# Response to Siting Board Staff's First Data Request to ecoPower Generation, LLC

Case No. 2009-00530

**RESPONSE TO SITING BOARD STAFF'S FIRST DATA REQUEST**  
**TO ECOPOWER GENERATION, LLC**  
**DATED MARCH 26, 2010**

**REVISED FIGURE J2**

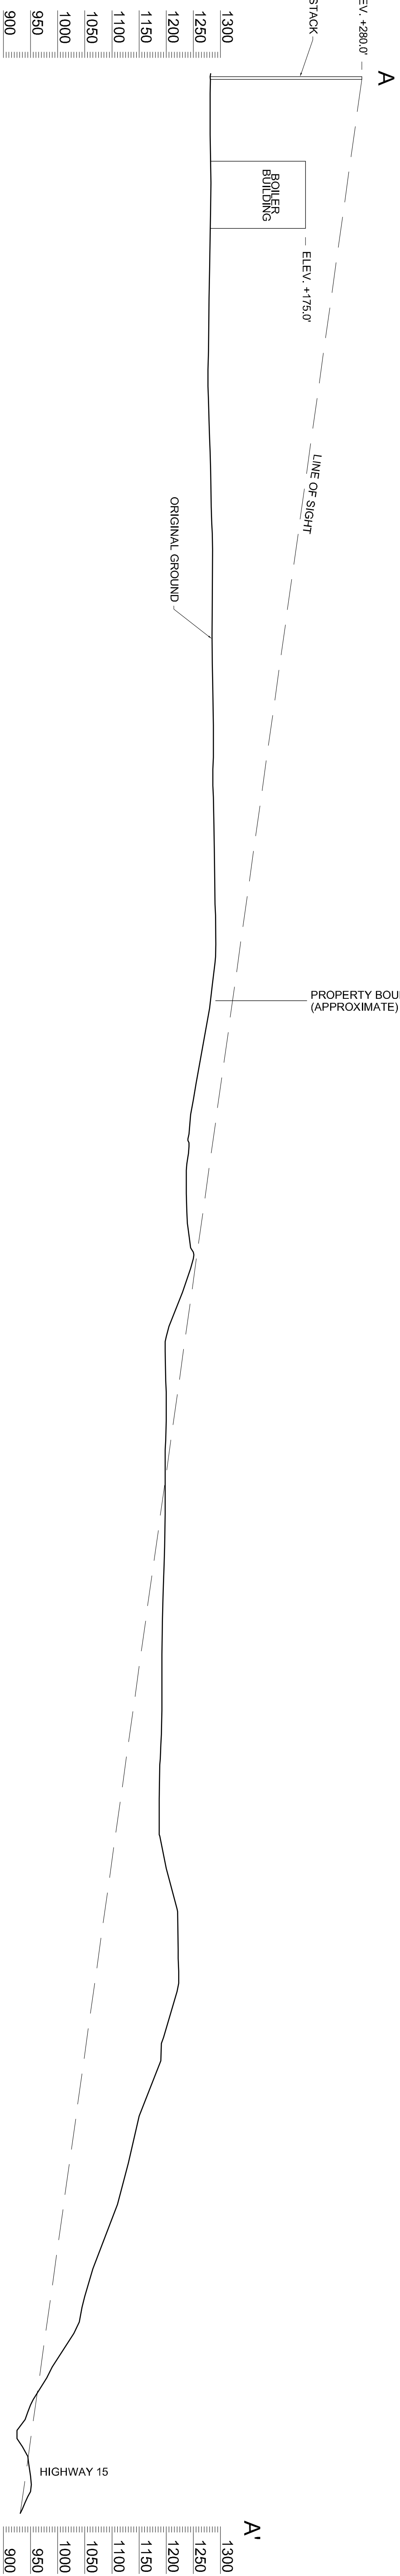
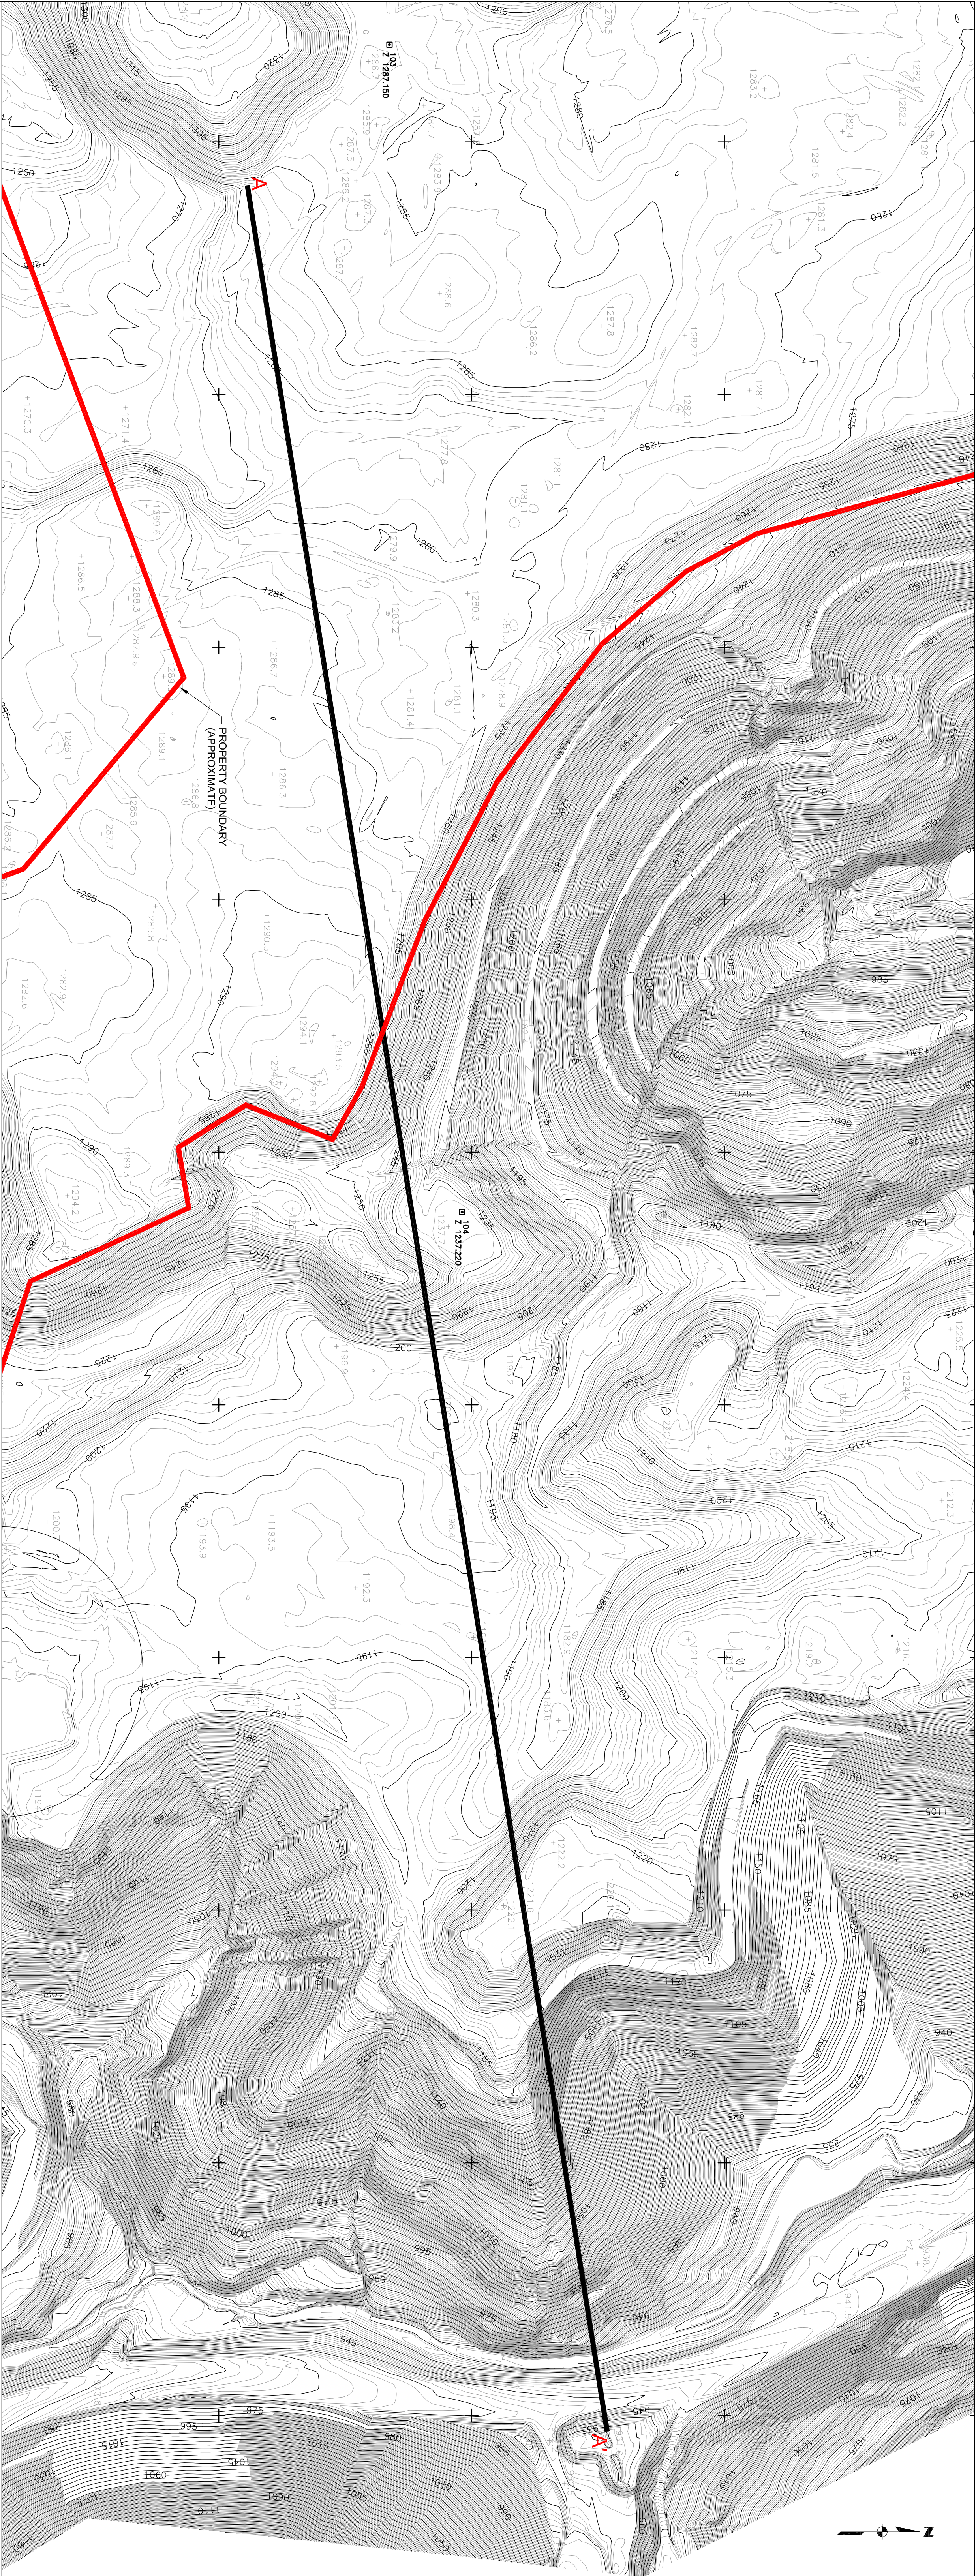
5) *Refer to Exhibit J, Figure J2 – Line of Sight Profile and Location Map. Provide labels for additional features on Figure J2 showing the site boundary, Highway 15, and existing development (homes and businesses).*

6) *Refer to Exhibit J, Figure J2 - Line of Sight Profile and Location Map. Figure J2 shows approximate line of site in an east-northeasterly direction. Explain whether a similar evaluation was conducted in the south direction (or any other direction from the site)?*

The location of Highway 15 is labeled on the profile on Figure J2. We have added the location of the property boundary and a revised Figure J2 is submitted with this information (refer to **Tab A**). The only development is along Highway 15 and generally consists of small, 1-2 story residential structures located at the toe of the slope. We have not measured heights of any buildings along Highway 15 but we can provide photographs depicting these structures. The slope of the hill prevents any view of the project site or proposed structures.

The line of sight plan and profile on Figure J2 is the only location where current topographic mapping created by the recent aerial survey can be integrated with topographic data from the USGS mapping, due to mining along the higher elevations. This is discussed in the Site Assessment Report – Exhibit J, at page 12, as follows:
